Demolition of existing buildings and construction of a 26-storey hotel building

124 Franklin Street, Adelaide SA 5000

020/A065/19

OVERVIEW

Figure 7 – Green Wall (Mezzanine Level)

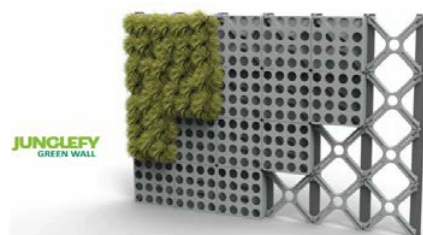
The GA was originally not persuaded that the proposal had fully explored the opportunities to incorporate the principles of ESD, and sought the applicant demonstrate the depth of the slab edges to ensure effectiveness of integrated solar shading, the dimension and details of the green wall including appropriate plant selection and maintenance strategy and the extent of solar panels. The applicant has since provided amended plans to address these matters and these details are shown in the ATTACHMENTS and below in Figures 7, 8 & 9. After review of these amended documents, the GA has now acknowledged and indicated support for:

- *Provision of further details of the depth of the slab edges and design intent for integrated solar shading.*
- *Confirmation of the dimensions, details and plant selection of the green wall.*
- *Confirmation of the location and extent of solar panels.*

Figure 11 – Waste Storage

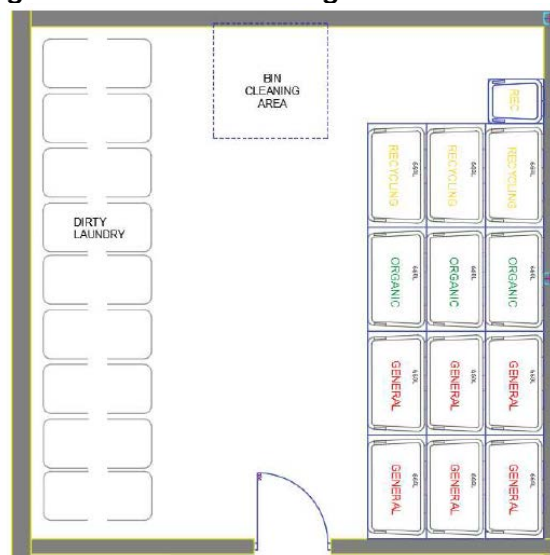
Based on these waste streams, adequate on-site storage is available as shown below in Figure 11:

Council has been referred the application and outlined support for the proposed Waste Management Plan proposed. Given this and the above advice provided from InfraPlan, the proposal is considered to have addressed the Development Plan requirements for waste management.

The images below display the evolution of the proposed design before the Design Review Panel to now.

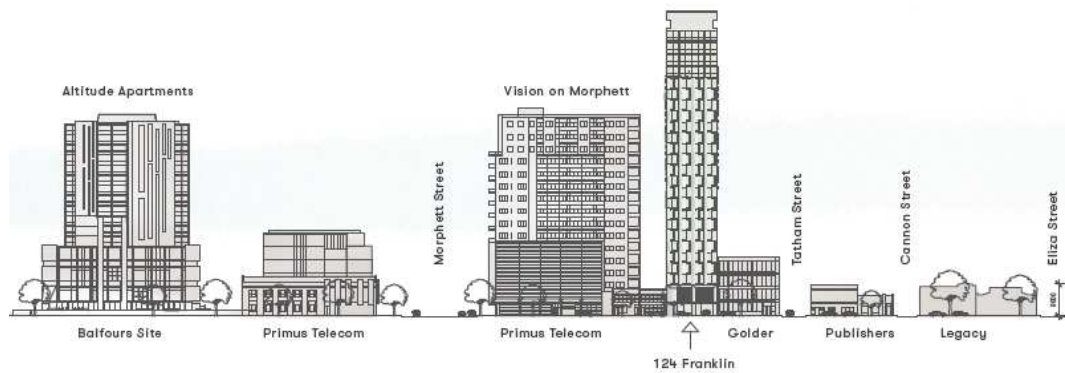
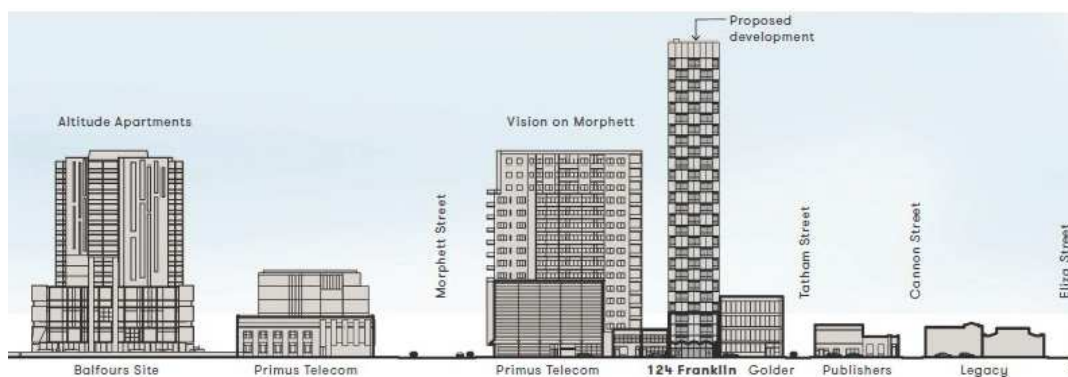
The proposed development provides a better-defined podium with articulation and features to enhance pedestrian experience with greater visual interest.
